09-14 LATEST REVISION DATE <i>Thomas E. McQuinn</i> APPROVED BY BRIDGE ENGINEER		
	STANDARD DESIGN STEEL OVERHEAD SIGN TRUSS SEPTEMBER, 2011	
	DMS RUNWAY DETAILS	SOST-12-11

50'-130' SPANS

SECTION G-G SECTION H-H SECTION J-J

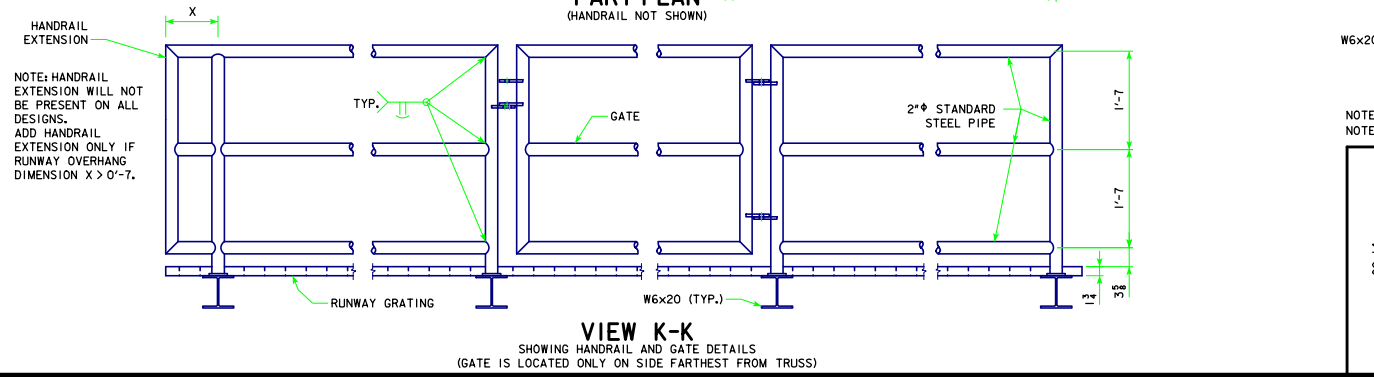
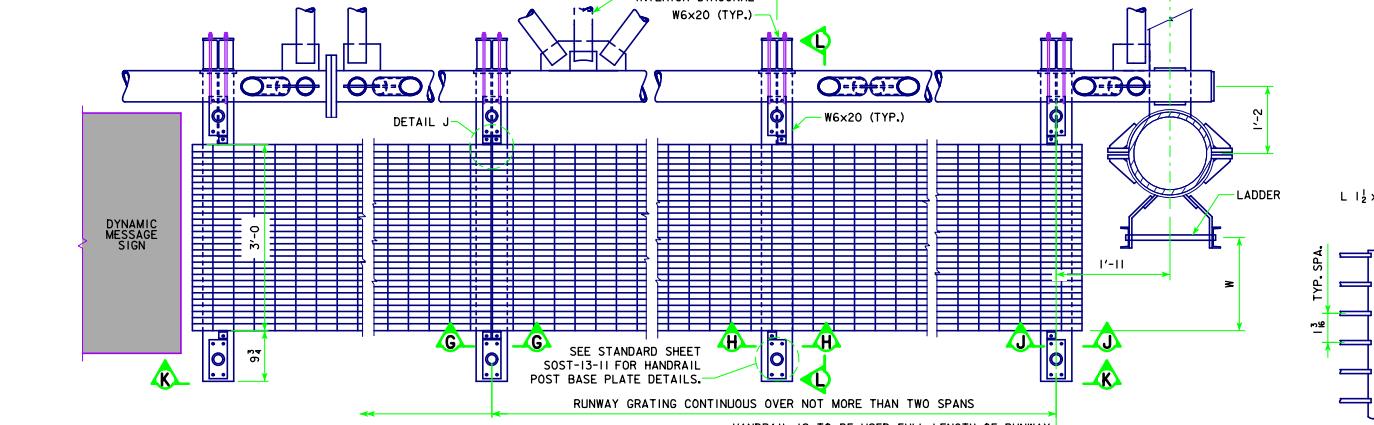
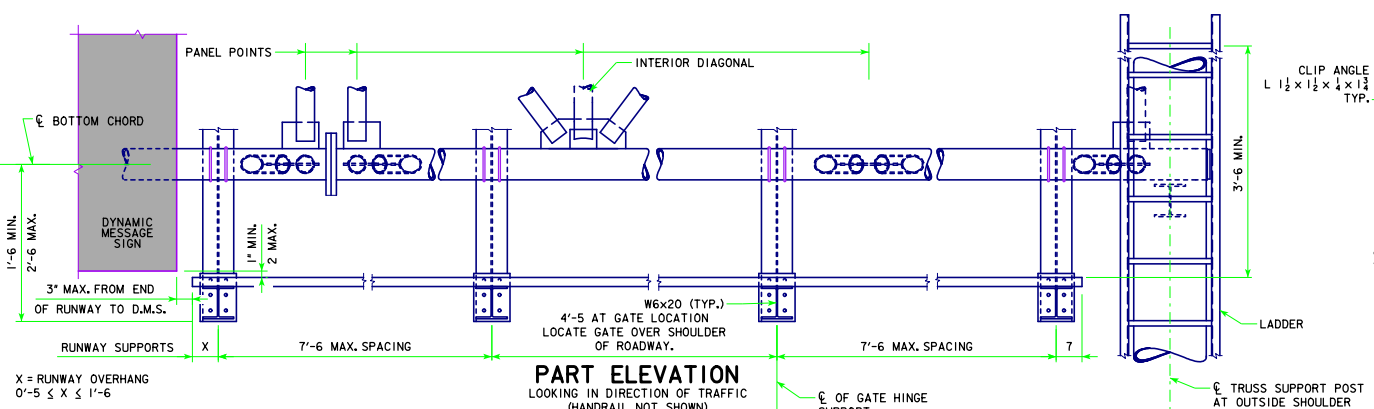
REVISION 09-14 - CHANGED TYPE AND GAGE OF HOLES IN W6x20 FOR CLIP-ANGLE BOLTS. STEELOVERHEADS\INTRUSS.DGN - SOST-12-11 - THIS SHEET ISSUED 03-13.

NOTES:
 DRILL $\frac{3}{8}$ " ϕ HOLE IN CLIP ANGLE AND $\frac{3}{8}$ " \times 1" SLOTTED HOLE IN W6x20 FOR $\frac{1}{2}$ " ϕ A325 GALVANIZED BOLT WITH WASHERS, NUT, AND JAM NUT. ADJUST CLIP SO GRATING BEARS ON BEAM.
 THE GALVANIZED STEEL BAR GRATING INCLUDING BEARING BAR, CROSS BARS, AND BANDING BARS SHALL COMPLY WITH THE REQUIREMENTS OF ASTM A1011 TYPE 2.
